REVISED FINAL WORK PLAN ADDENDUM UNNAMED STREAM NAS FORT WORTH TX
3/1/1999
FANNING, PHILLIPS AND MOLNAR

**REVISED FINAL
WORK PLAN ADDENDUM
UNNAMED STREAM
CDRL A004**

Contractor Response to Unnamed Stream Site Comments from AFCEE

Contractor Response to Unnamed Stream Site Comments from USEPA/TNRCC

UNITED STATES AIR FORCE NAS FORT WORTH, CARSWELL FIELD FORT WORTH, TEXAS	
FIGURE 1-2. PREVIOUS SAMPLING LOCATIONS & PROPOSED AREAS OF INVESTIGATION AT THE UNNAMED STREAM	
Drawn By: A.L.	Checked By: T.D. Date: 11/08/98

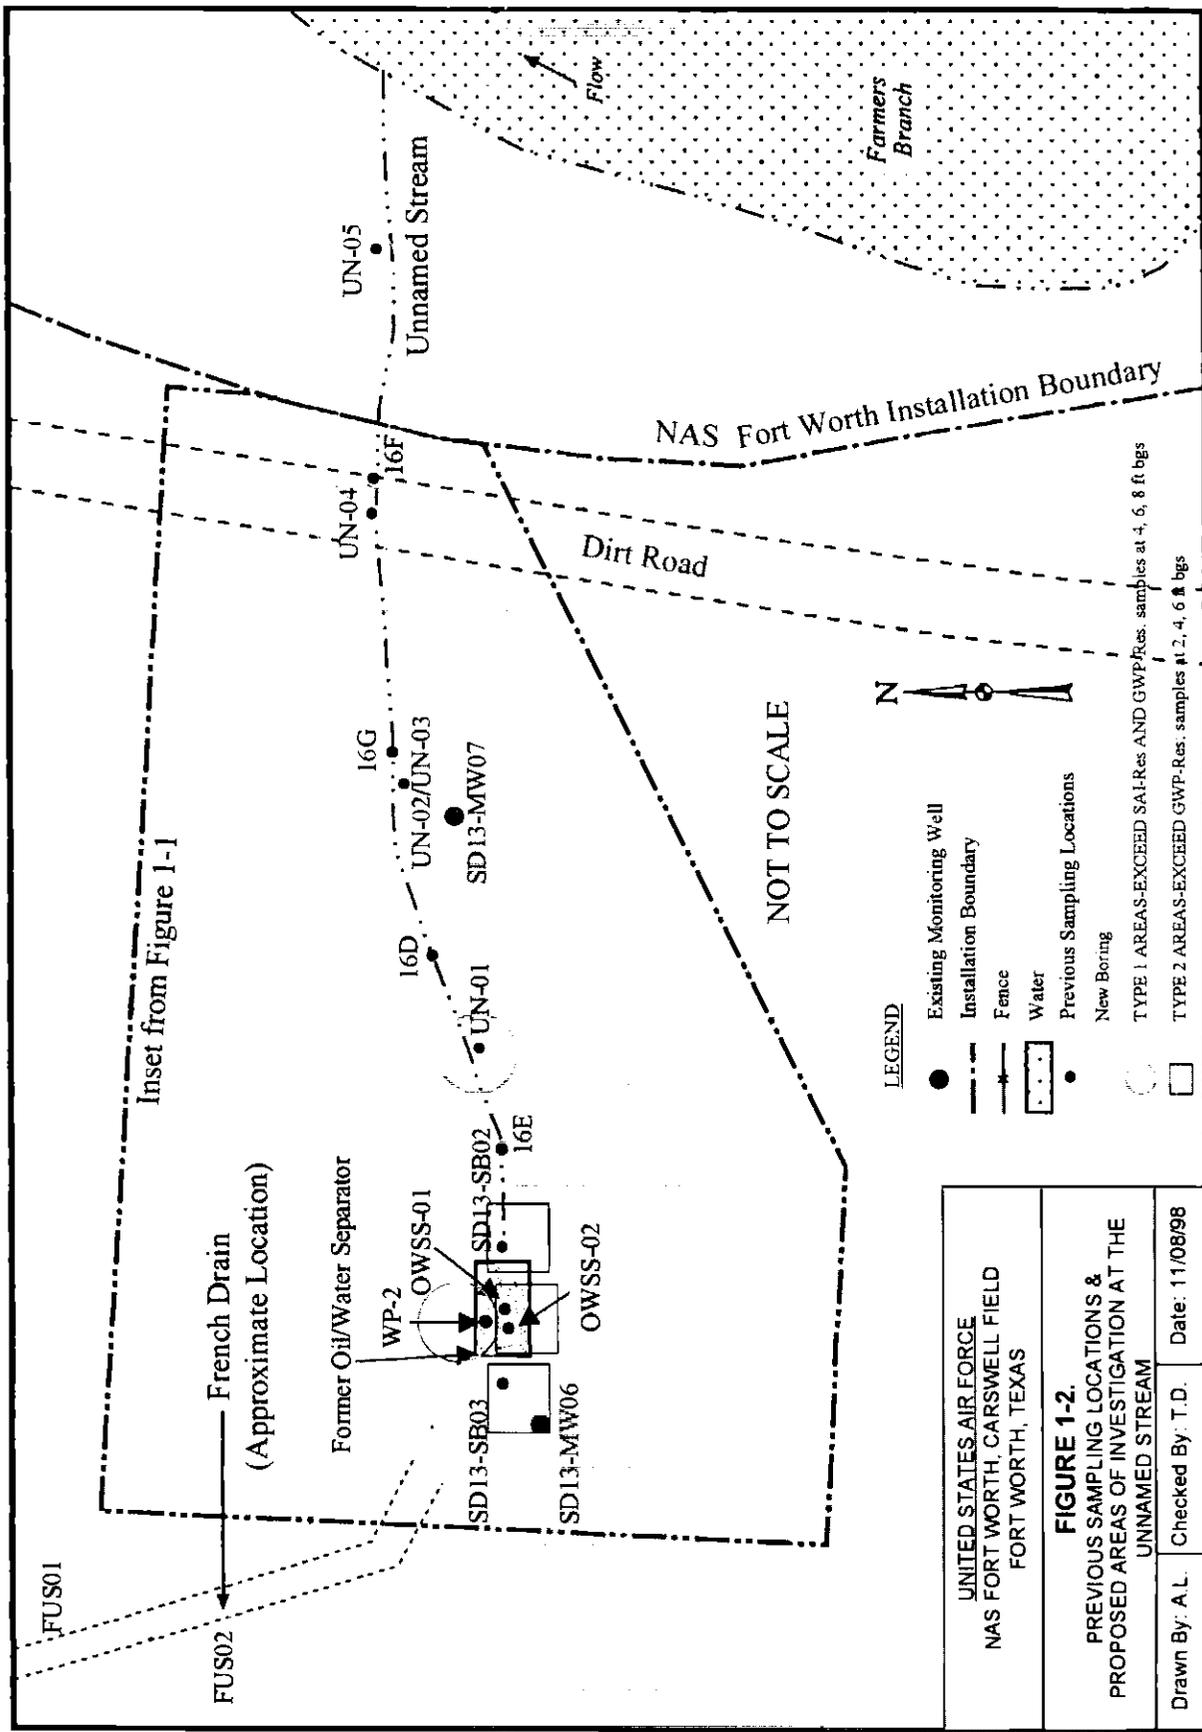
10		Figure 1-2	It is recommended that the Contractor include an additional figure that would illustrate proposed initial sample locations.	Revised legend for clarification. The initial sample locations are the areas indicated on the figure. As section 3.6 explains, samples will be taken in 2 feet vertical intervals at each location and radially out to 15 feet.
